Video Products Technical Bulletin 30-2005-143

SUBJECT: REUSE PARTS WHEN REPLACING EA BOARD

MODEL: **BVM-1316**
BVM-1316C
BVM-1415C
BVM-1415P
BVM-1416P

Figure 1

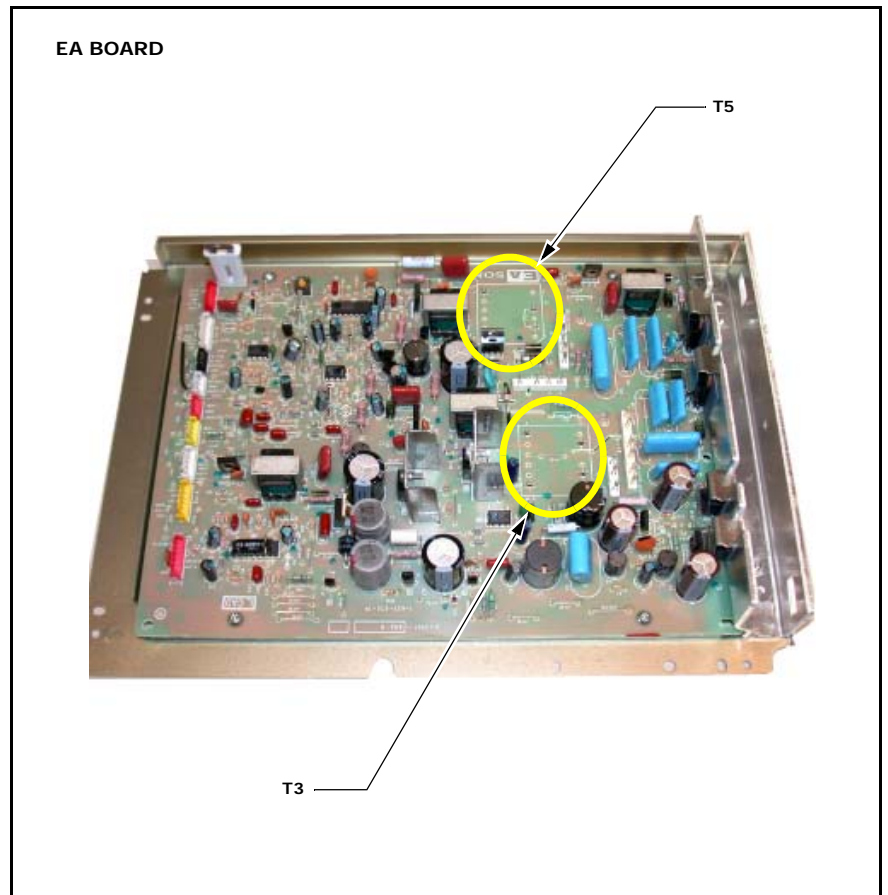
When you replace the EA board (A-1345-802-A/B), remove the following parts from the former board and install them on the new board.

Ref. No.	Description	Part No.
T3	HOT	1-439-383-11
T5	LOT	1-439-384-11

The new EA board does not contain the parts, and the parts are no longer available. (See Figure 1.)
